SUBSURFACE SEWAGE TREATMENT SYSTEM COMPLIANCE REPORT

Date: August 7, 2017 **Time:** 12:00 PM **Owner:** Daniel & Lynda Semlak
Inspection Address: 9997 Justen Trail North, Grant, MN 55115

Compliance Inspection Form

Log Of Soil Borings

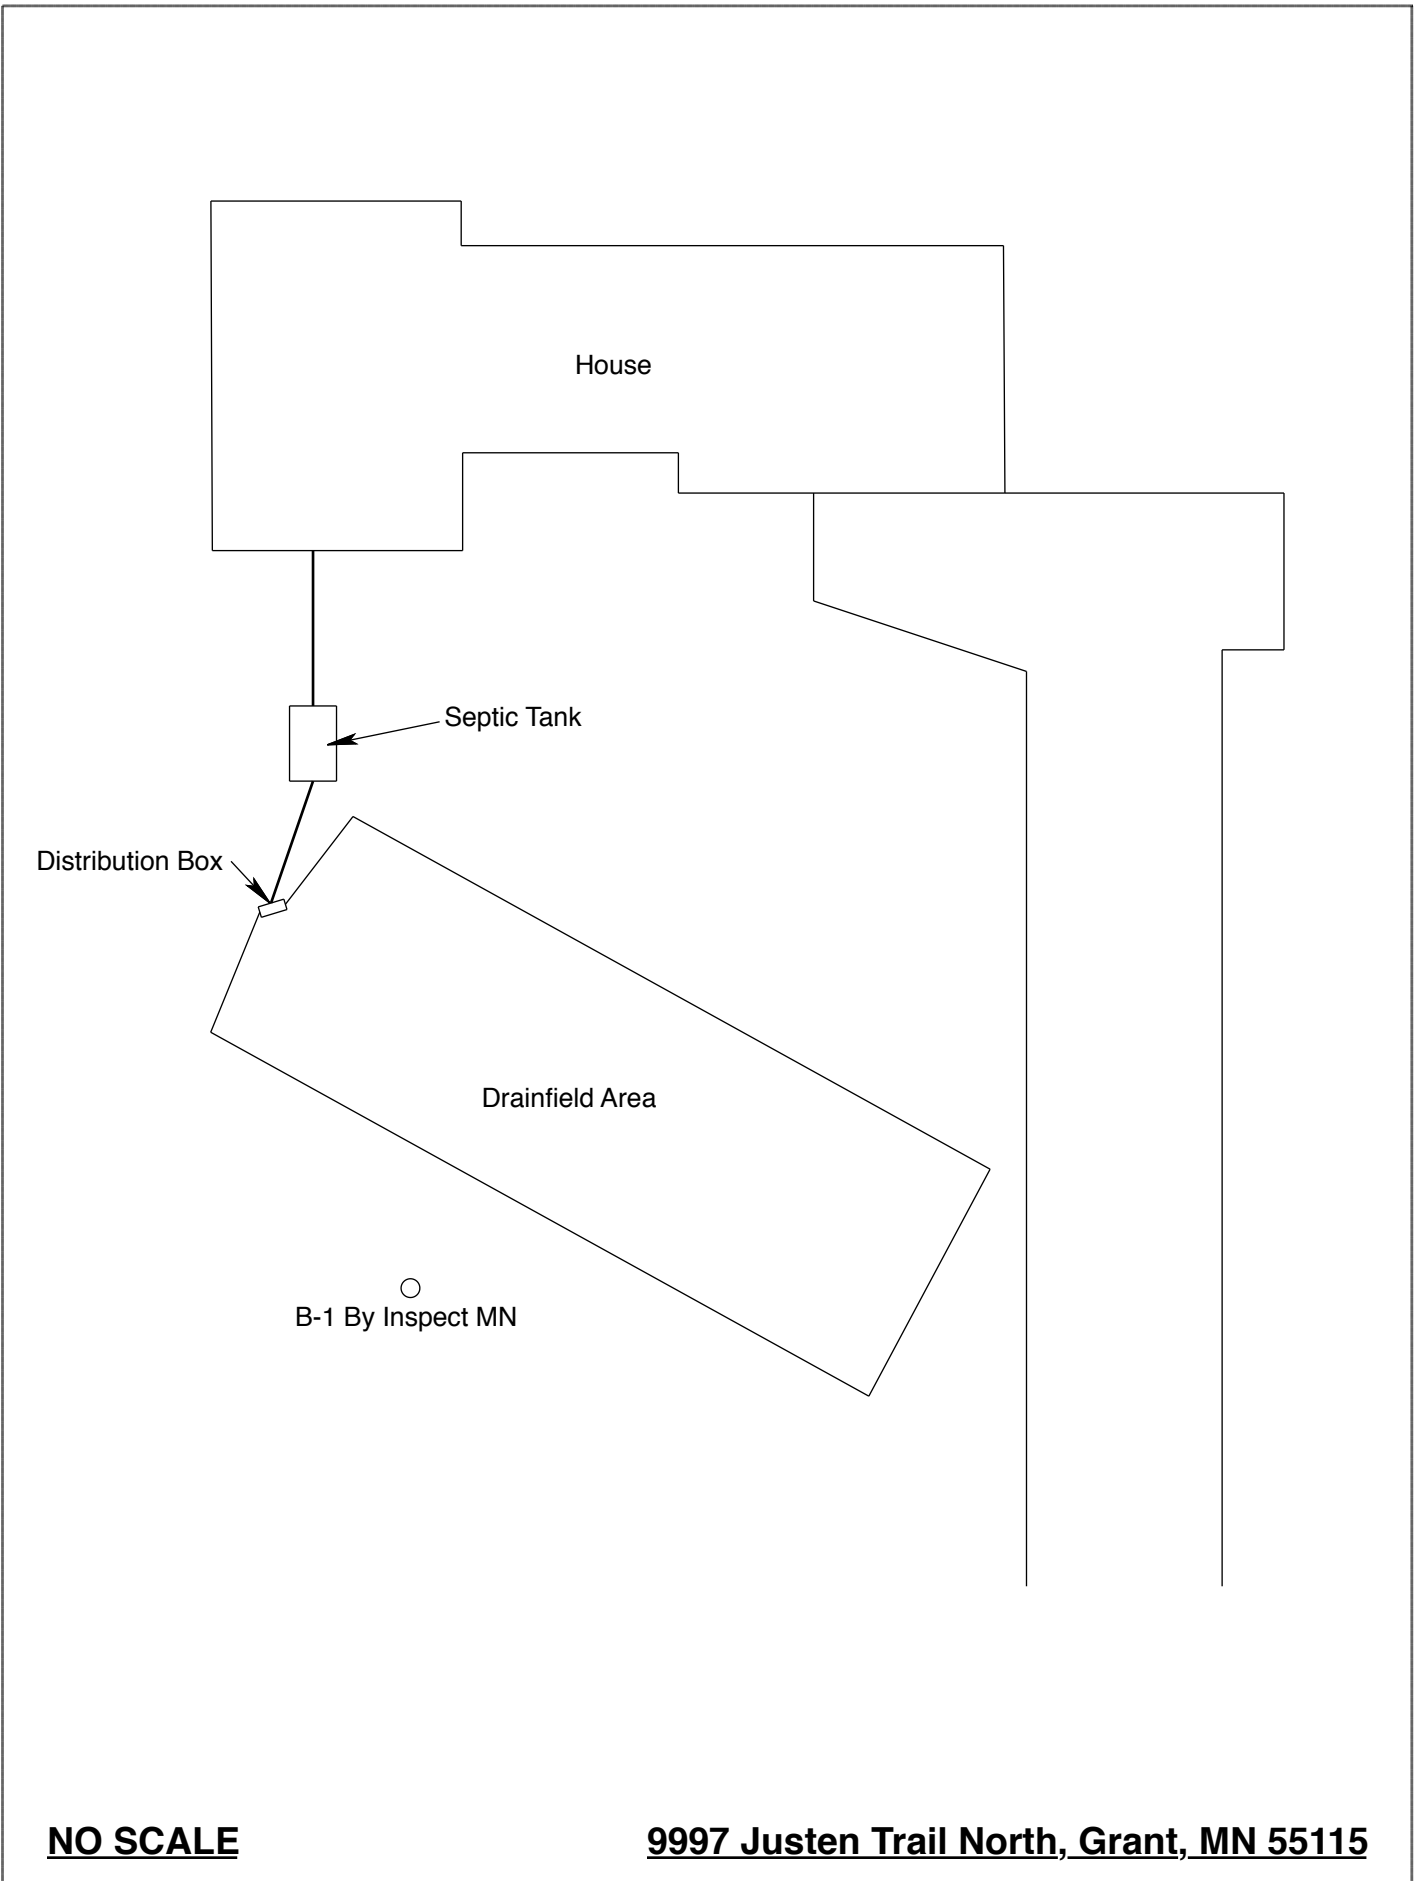
My inspection indicates that this system is presently “non-compliant” in accordance with MPCA rules 7080.1500 Subp.4(B)(E) because of the lack of the required two foot separation between the bottom of the drainfield and seasonally saturated soils.

Location of Project:		9997 Justen Trail North, Grant, MN 55115	
Borings Made By:		Inspect Minnesota	Date: 8/7/18
Auger Used:		Hand/Bucket	Classification System: USDA
Boring Number:		1	Boring Number:
Surface Elevation of Boring	Same ground surface as last drainfield trench		Surface Elevation of Boring
Depth In Inches	<u>Soils Encountered</u>		Depth In Inches
0-16	10YR 4/2 Fine Sand		
16-29	10YR 4/3 Fine Sand		
29-39	10YR 4/4 Fine sand		
39-47	10YR 4/4 Loamy Fine Sand With 7.5YR 4/4 Medium Sand Layers		
47-52	7.5YR 4/4 Medium To Fine Sand		
52-64	7.5YR 4/4 Medium To Fine Sand With 10YR 7/2 Silt Layers And 7.5YR 5/8 & 5YR 3/4 Redox		
52"	Depth To End Of Boring Or Redox		Depth To End Of Boring Or Redox
Same	Elevation Of Boring Relative To System		Elevation Of Boring Relative To System
-41"	Depth To Bottom Of Distribution Media		Depth To Bottom Of Distribution Media
=11"	Of Separation		Of Separation
End Of Boring At:	64"		End Of Boring At:

Redox Present At:	52"		Redox Present At:
Standing Water Present At:	None		Standing Water Present At:

Bottom Of Distribution Medium At: 41 Inches
